P 27713  
A Repair

# PERMIT

SEWAGE DISPOSAL SYSTEM

RE: Nichols D-13760 (House addition)

P27713

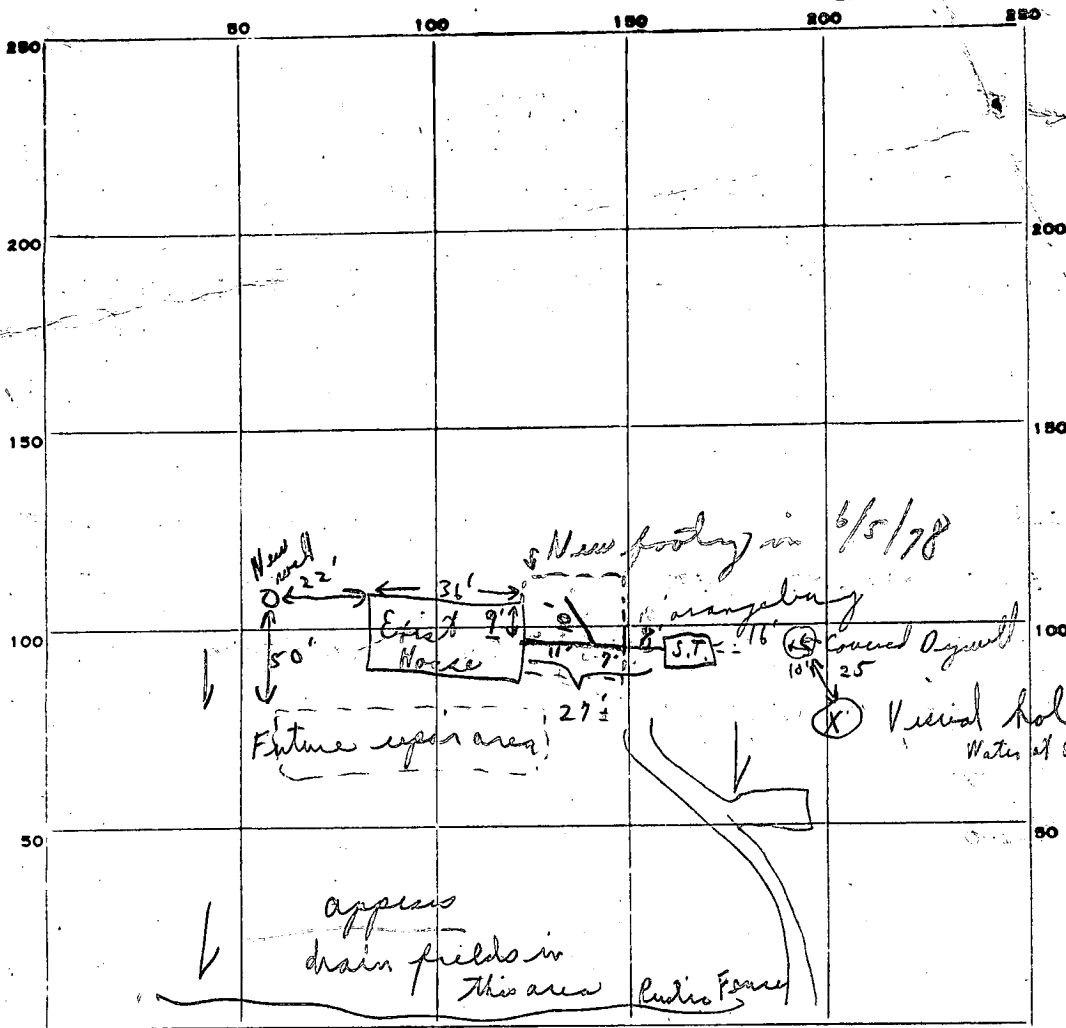
sandy loam  
 to  
 Hole 11' originally  
 Water 5 1/2' of grade  
 4/25/78  
 Mr. Sterling

REMARKS ① Saw cast iron pipe at house; ② Orangelburg at + from septic tank closest to house; ③ 11' Recommend replace pipe from house to tanks with all cast iron, hold for Mr. Monaghan - he agrees call + explain ok to put addition on - if replaces, pipes with cast iron. 6/5/78 all cast iron from house to septic tanks 6/5/78 pipes above footing & term of check. closer

DATE SYSTEM APPROVED \_\_\_\_\_ 6/5/78 \_\_\_\_\_ INSPECTOR C. B. Stricker

Field sheet

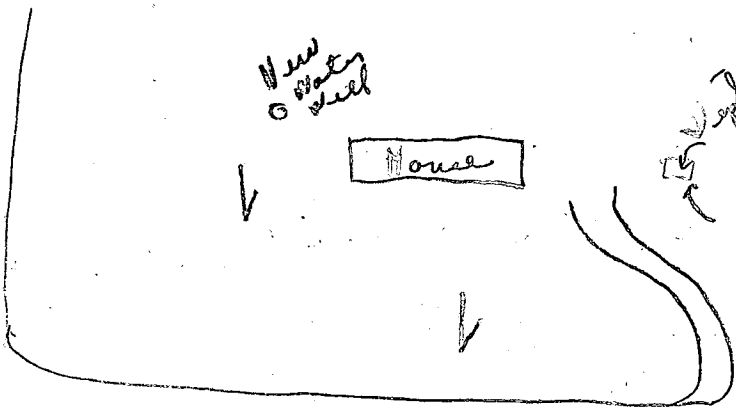
CONDITION FOUND 3/14/78 see other side; owner showed sanitation where septic system was located. No copy of system with this inquiry. (No apparent overflow.)

all clean out, covered this date.

No overflow noted ✓ hold for drawing from owner. }  
ACTION TAKEN Mr. Starling home! }  
check ✓

all covered at time  
of inspection

3/20/78 Referred drawing & plans to Mr. Monaghan to decide on future action - please note a bath is to be in new addition Mr. Monaghan.  
C.B.D.
